- ORIGINATION FORM -

Proposed Revisions to a Standard Plans Index (Please provide all information — Incomplete forms will be returned)

Index Number: 455-400 Sheet Number (s): 1 Index Title: Precast Concrete Sheet Pile Wall (Conventional)

NOILS AN	D DLIAILS
ILE WALL	INDEX	SHEET
	455-400	1 of 4

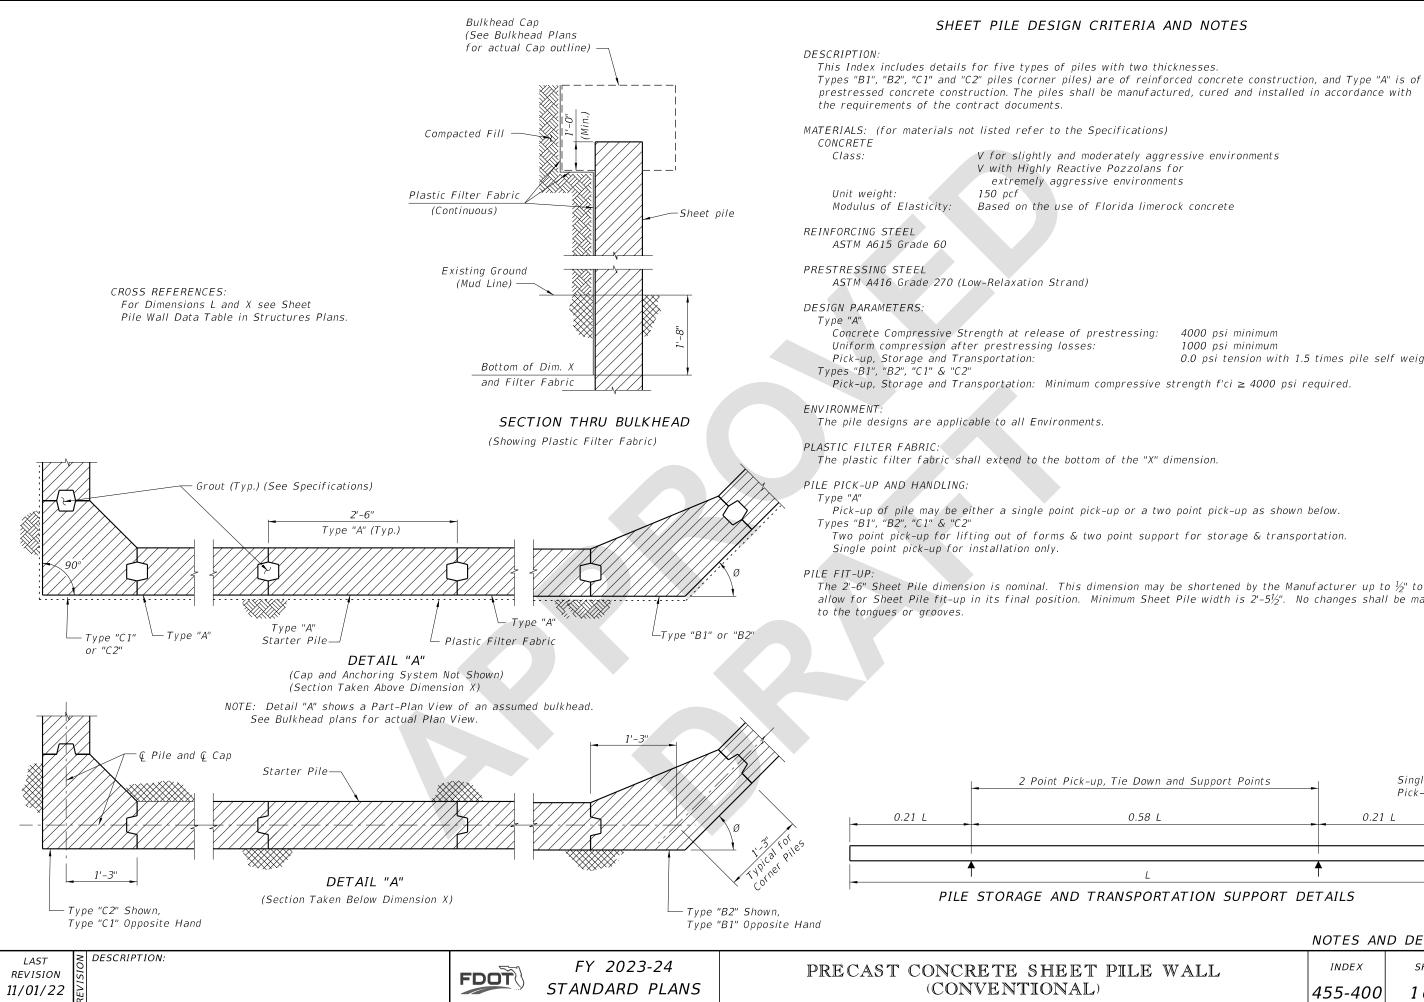
Changed Class V (Special) concrete to Class V.

V for slightly and moderately aggressive environments
